APPENDIX D:
STAGE 2 - NOTICE OF MODIFICATION

Notice of Modification

Project Approval 08_0135 for the Moolarben Coal Project Stage 2, granted by the Planning and Assessment Commission Minister for Planning on 30 January 2015.

Figure 2.1 – Indicative General Arrangement

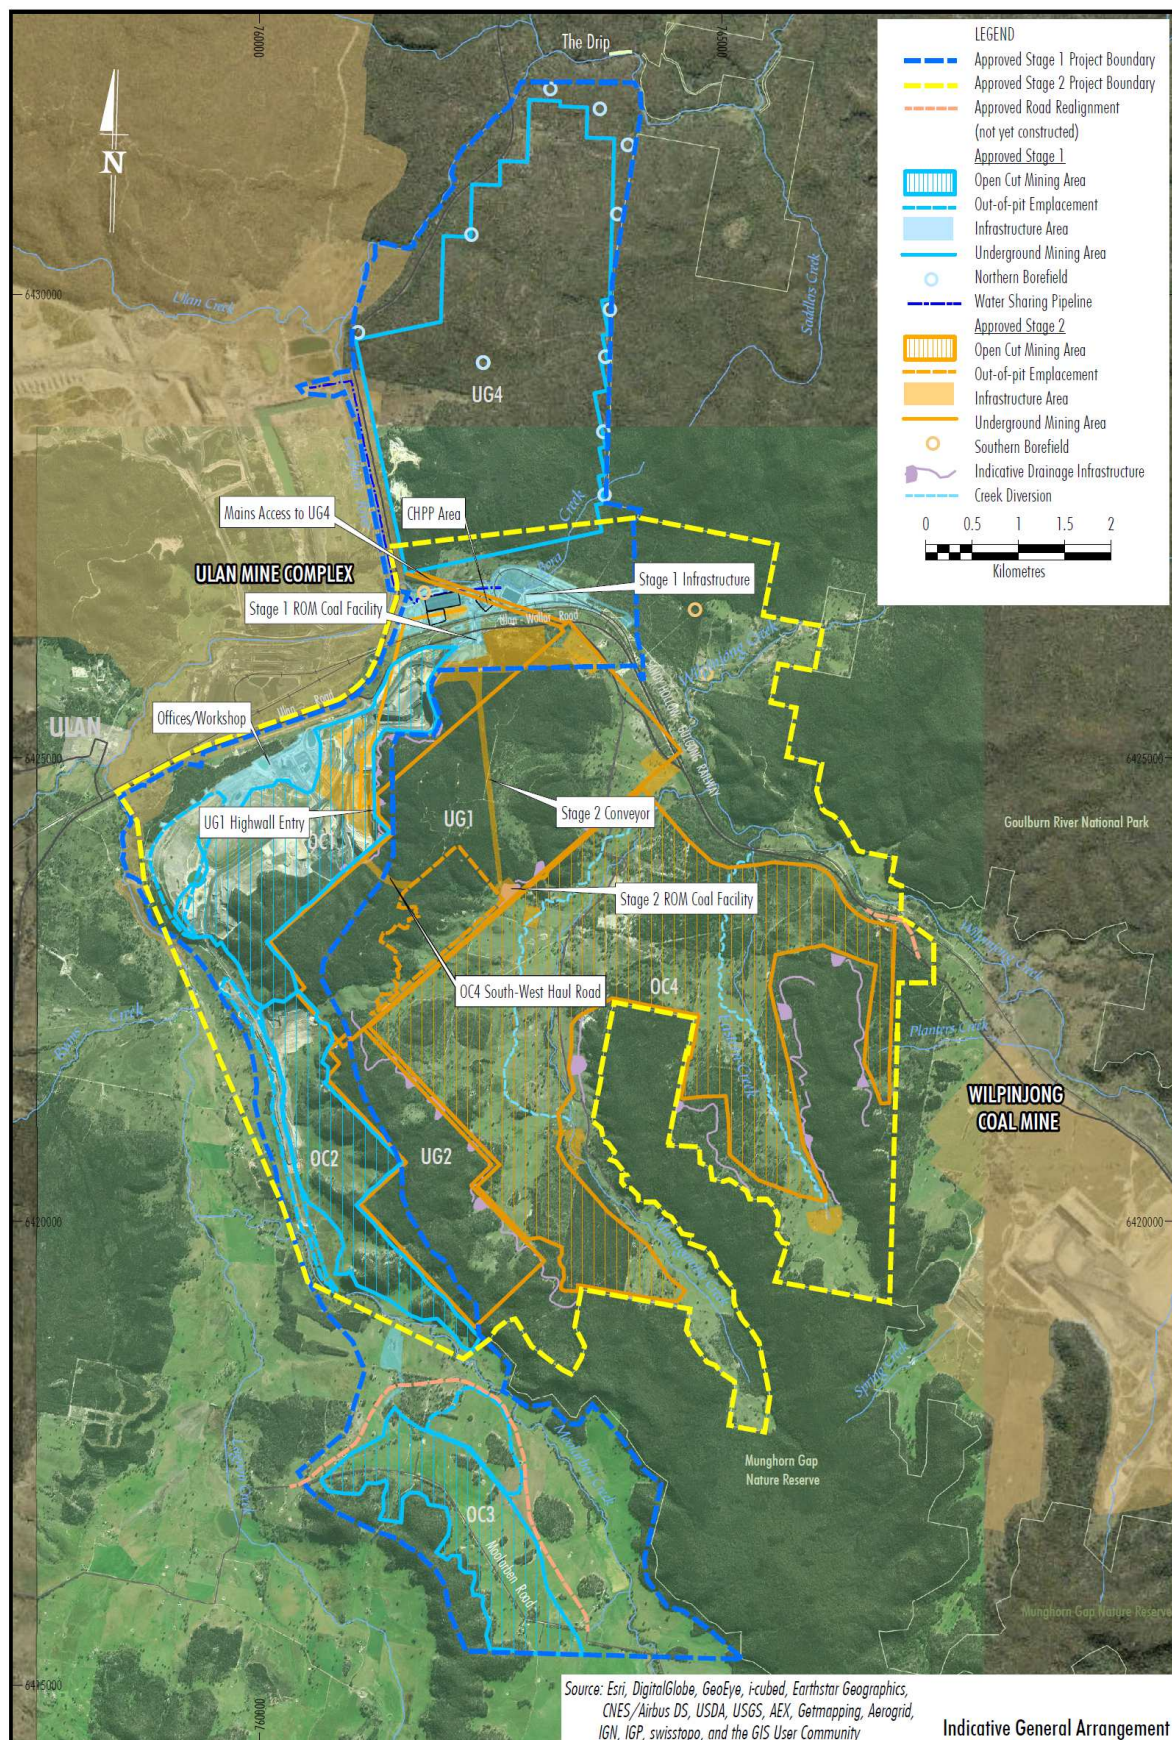
20. In Appendix 2 replace all figures with the following:

Figure 4.1 – Natural and Heritage Features

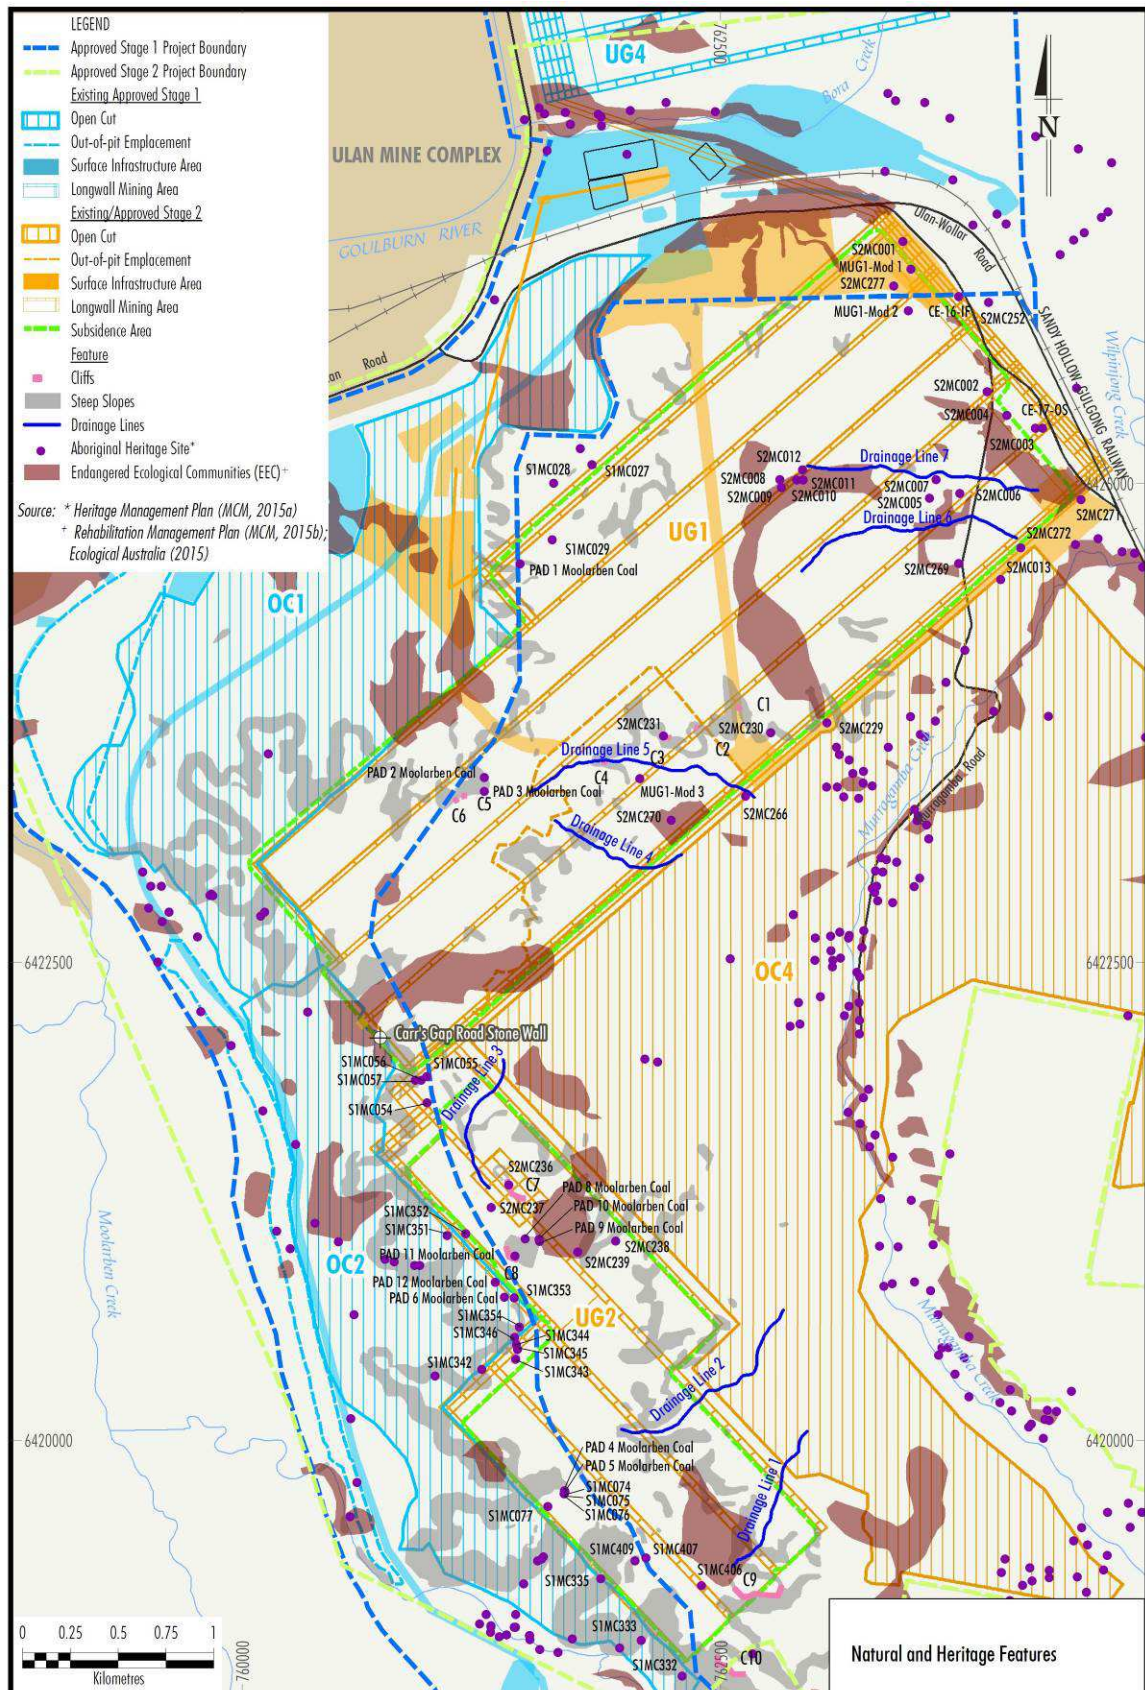
21. In Appendix 4 replace all figures with the following:

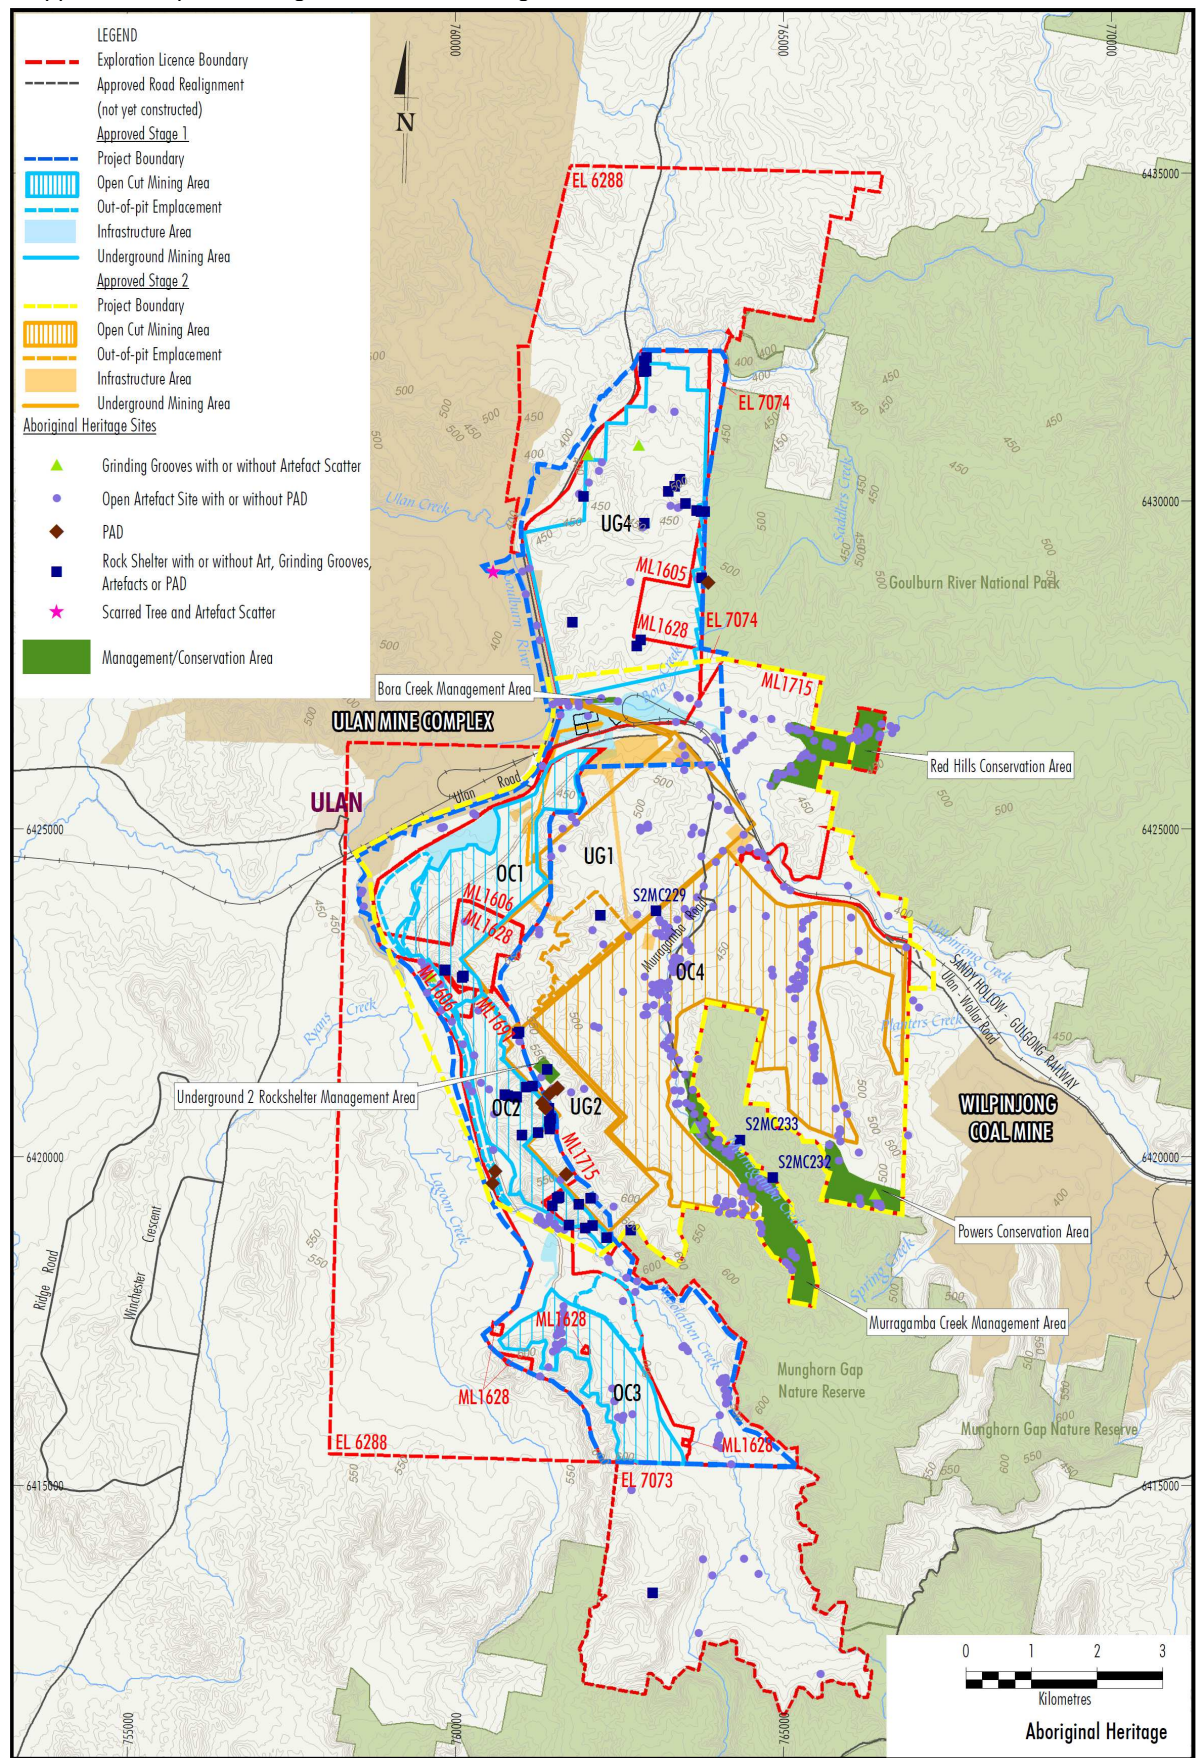
22. In Appendix 8 replace the figure with the following

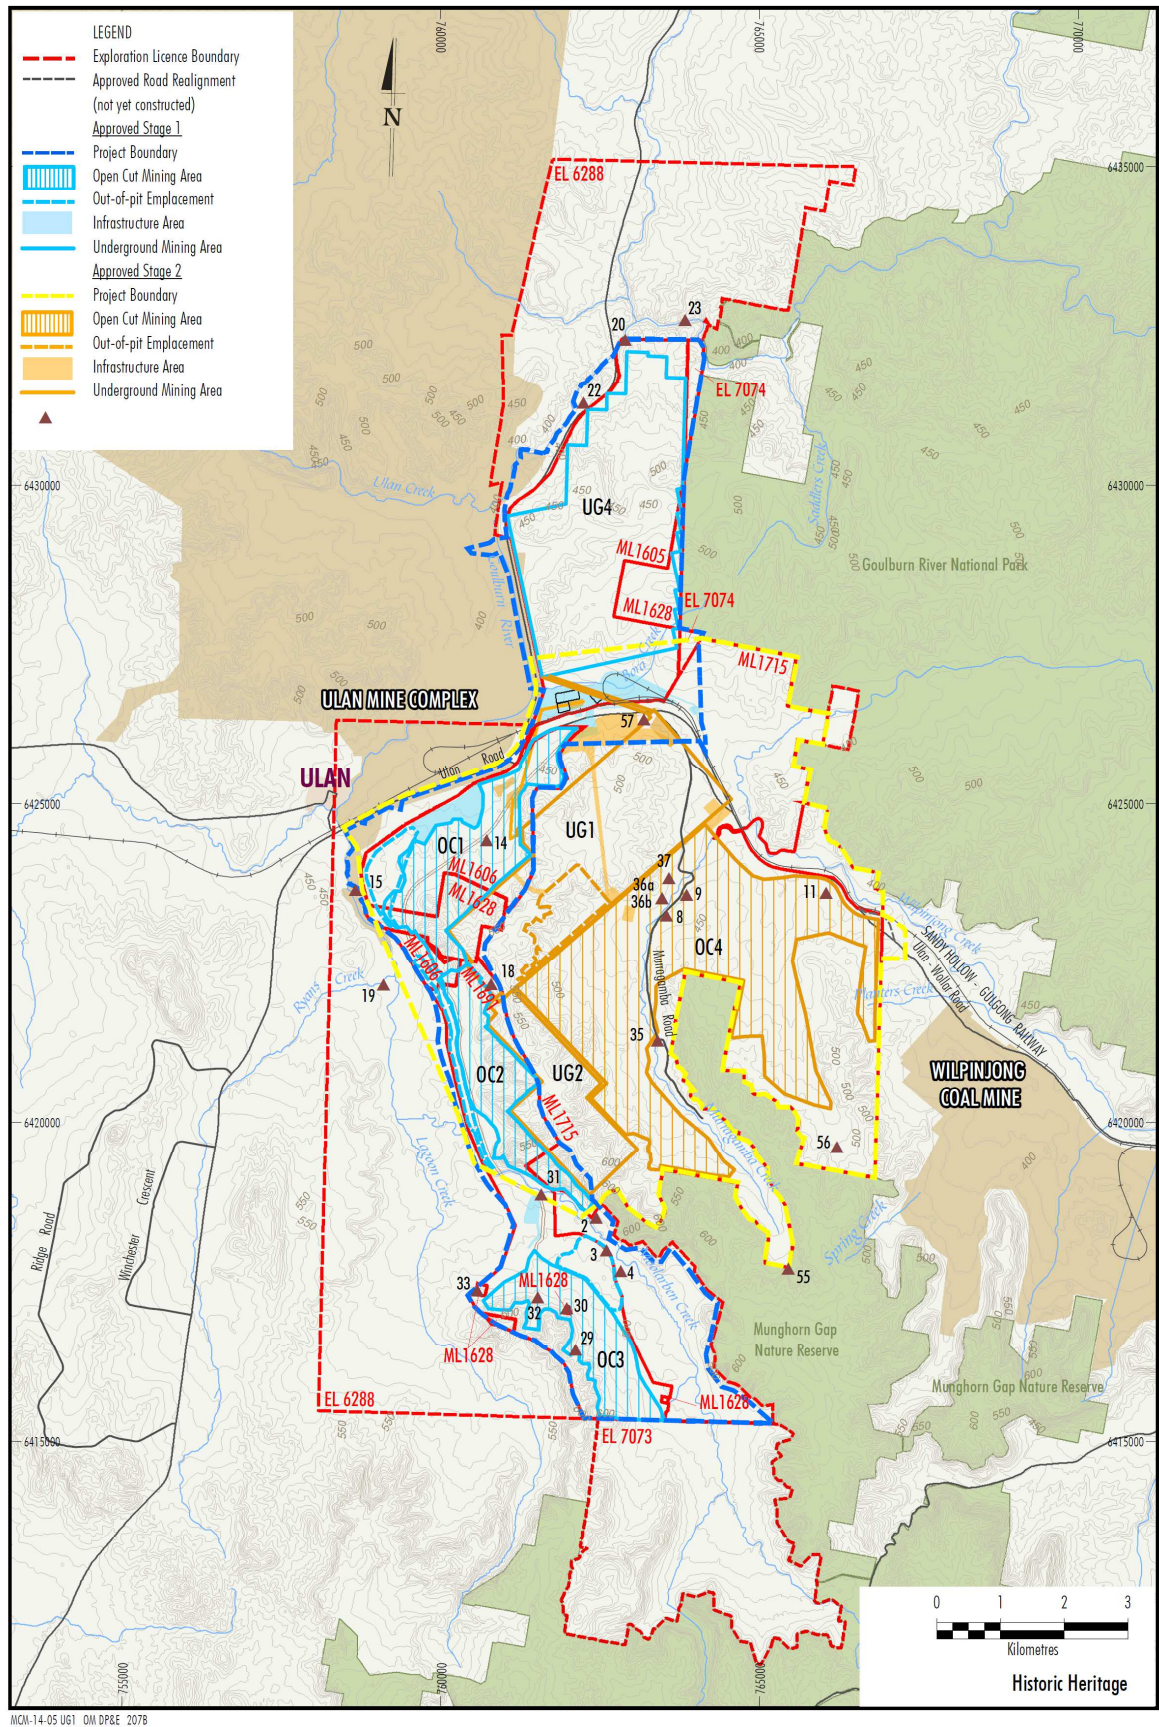
24. In Appendix 9 replace the figure with the following:
